#### 2024 State Touring Routes PIM #1, Hybrid Format

Project/File:	192800236
Date/Time:	Wednesday July 26 / 5:30 pm
Location:	Arnett Library
Next Meeting:	TBD
Attendees:	See Attached Sign-In Sheet
Distribution:	Project Website

2024 State Touring Routes Milling & Resurfacing West Main Street (Churchlea Place to W Broad Street) South Plymouth Avenue (Genesee Street to Ford Street)

#### 5. Ford Street Roundabout

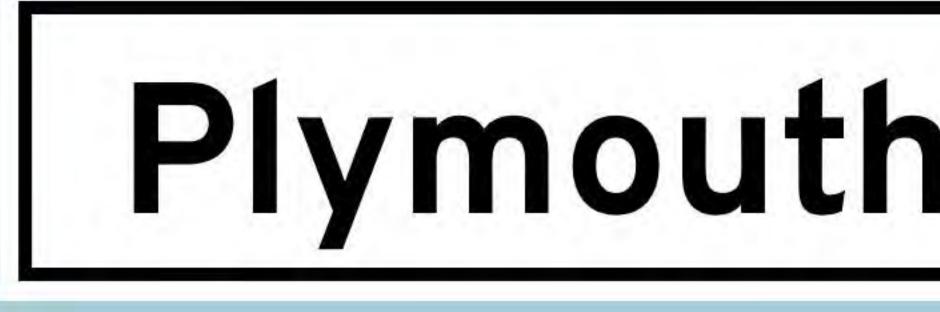
I'll keep this short and simple—cycle tracks are great, but not providing for bicycle left turns is highly problematic. Please strongly consider utilizing standard bicycle-friendly roundabout designs in order to facilitate bicycle traffic in all directions.

## Plymouth Gardens Bus Stop

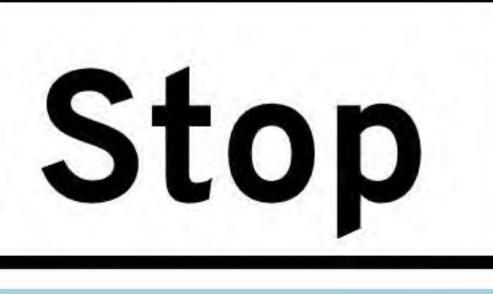
In order to maintain the cycle tracks behind the north-bound bus stop across from plymouth gardens, there would be enough space for the following configuration (west to east) as an alternative to Curb Bumpouts

- 11 foot southbound travel lane
- 11 foot northbound travel lane
- 8 foot bus boarding island
- 10 foot 2-way raised cycle track
